WATER PERMIT NO. 6635-3

Application For Permit To Appropriate Water Within The State Of South Dakota

We have reviewed the plans and specifications for your dam project located in the SE ¼ NE ¼ of Sec. 8-T121N-R50W, in Grant County. The plans and specifications for your dam are approved. Approval of the plans and specifications does not authorize construction of the dam. The construction of the dam may not begin until Water Permit No. 6635-3 is approved.

REPORT ON
WATER PERMIT APPLICATION No. 6635-3
Marie O'Farrell
August 12, 2005

12/21/05 Date
Designed Pete Anderson Approved by: PEA
revised 5/16/05 Title: Ag. Eng.
Drawn
Checked John Sten 2/1/06 Sheet 1 of 5 File Name: JP1.1

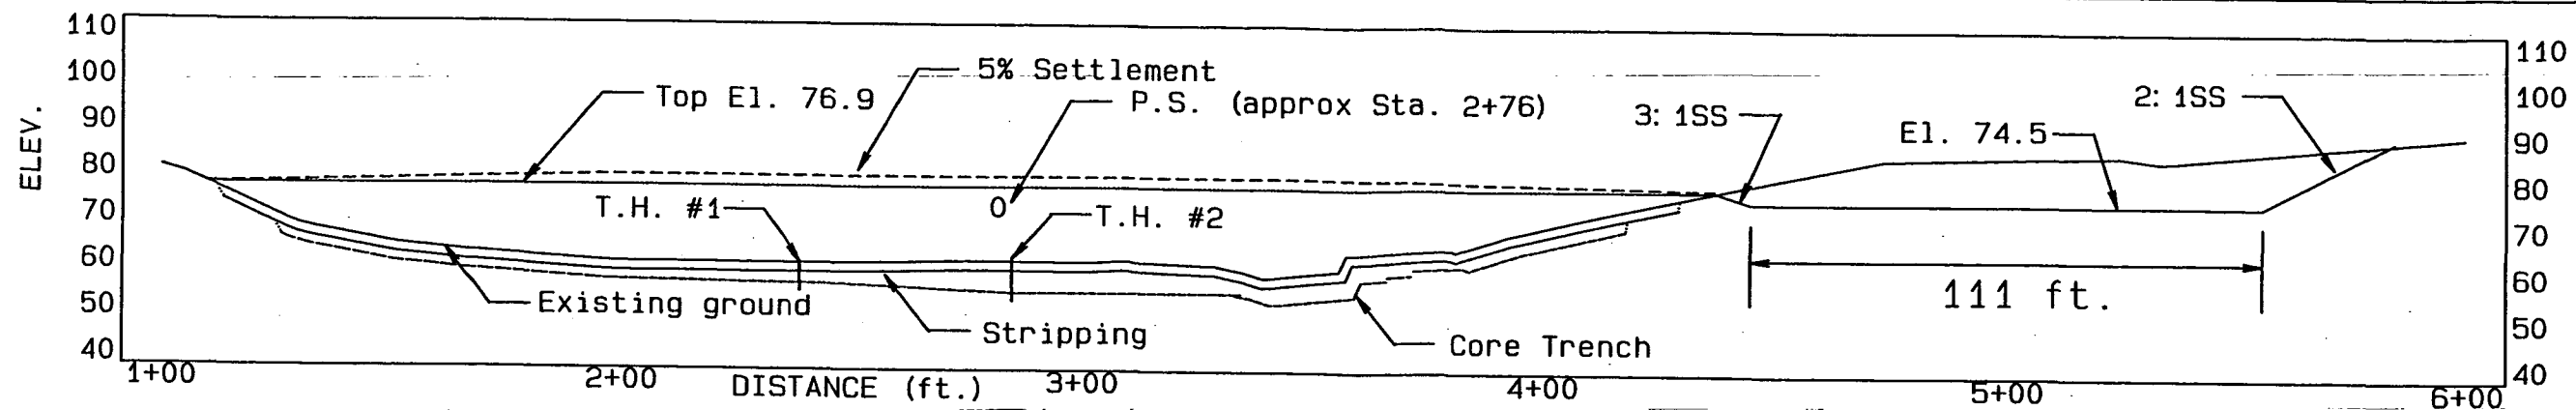
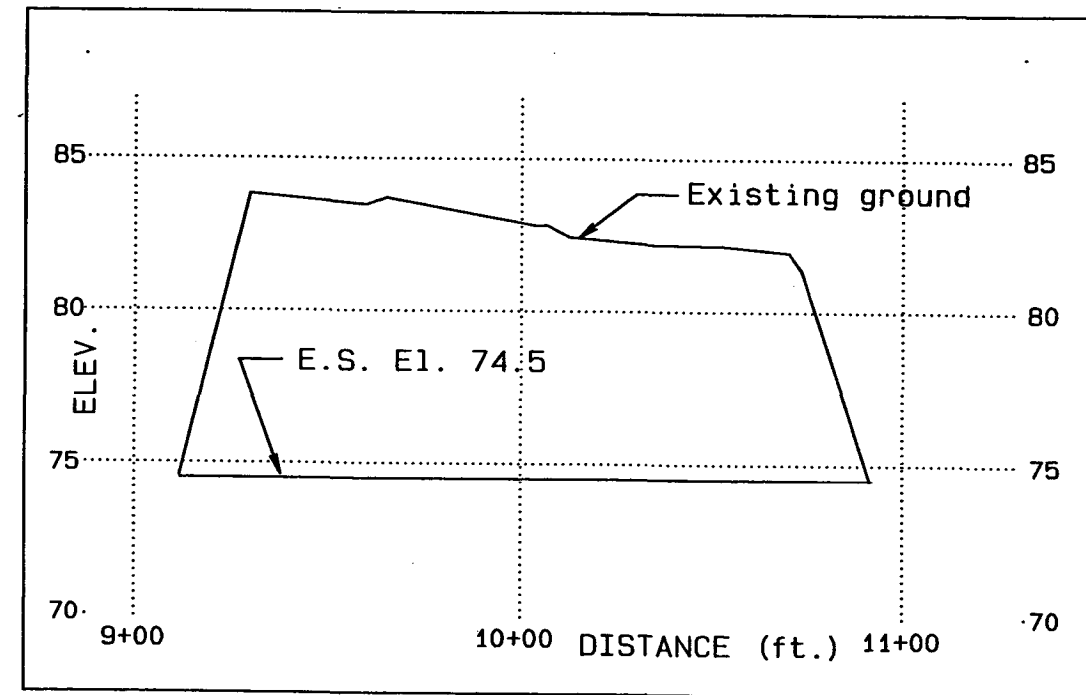
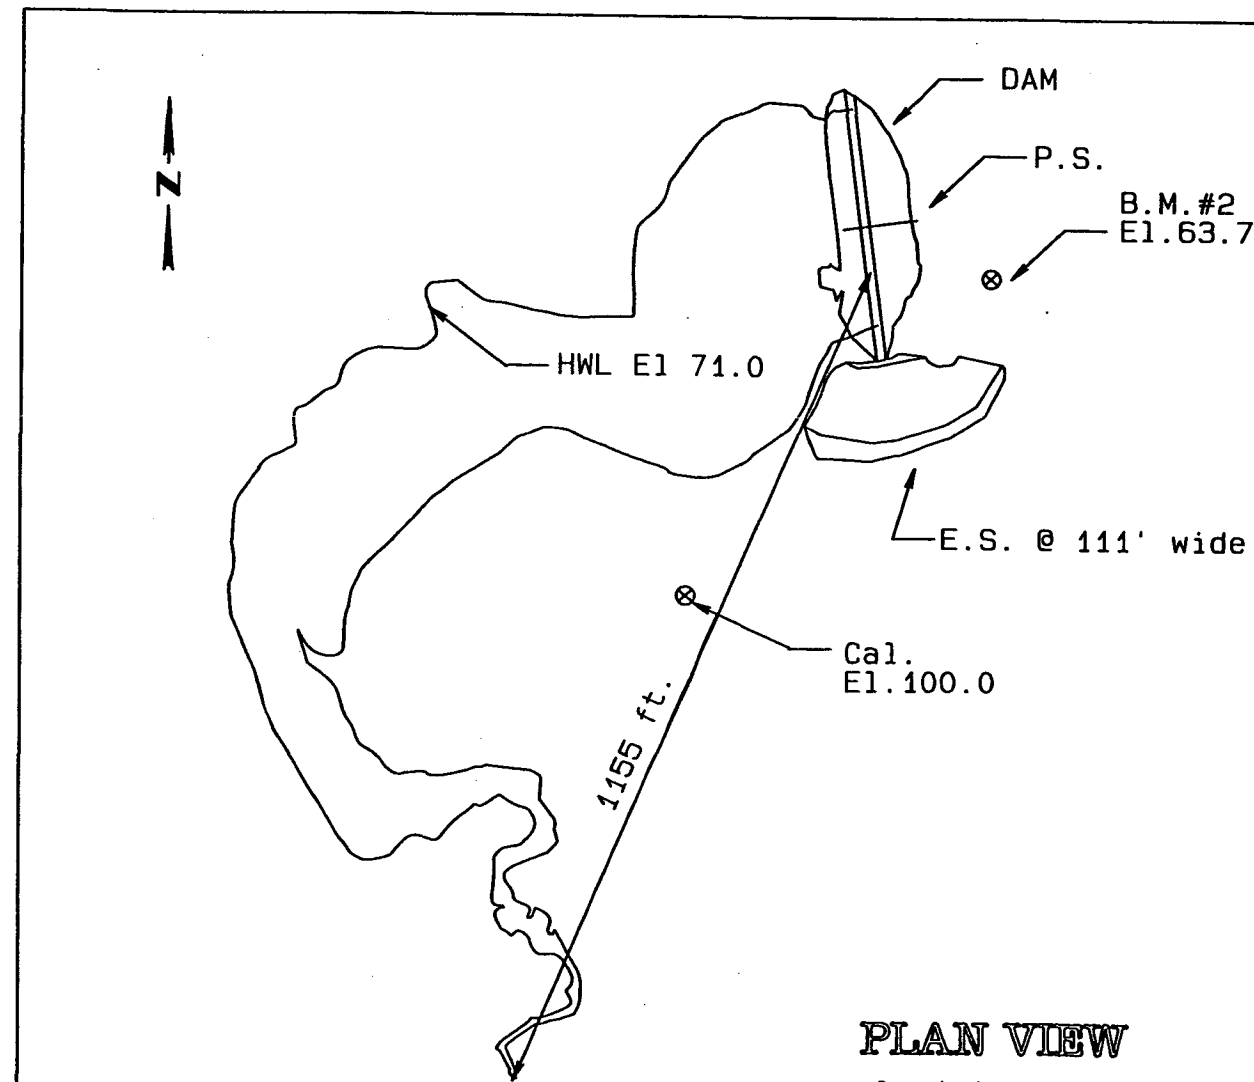
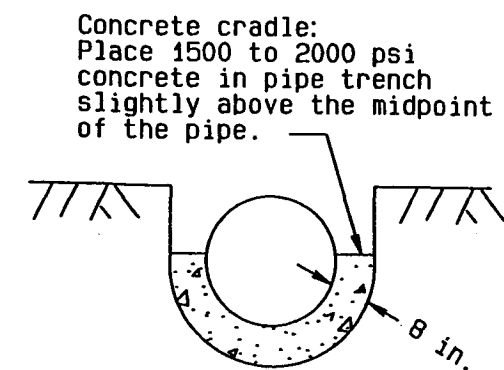
Int Capacity x Eff Ht. = $63 \times 16.7 = 1052 < 3000 \therefore 25\%$
Minimum Spillway Design

1. Topo Map - OK
2. Dam Axis Profile - OK
3. Dam Max. X-Sec. - OK
4. Area - Capacity - OK
5. Outlet Details - OK
6. Spillway Rating - OK
7. Spillway Details - OK
8. Specs. - Std. NRCS - OK
9. EPP - N/A Cat. 3 - OK
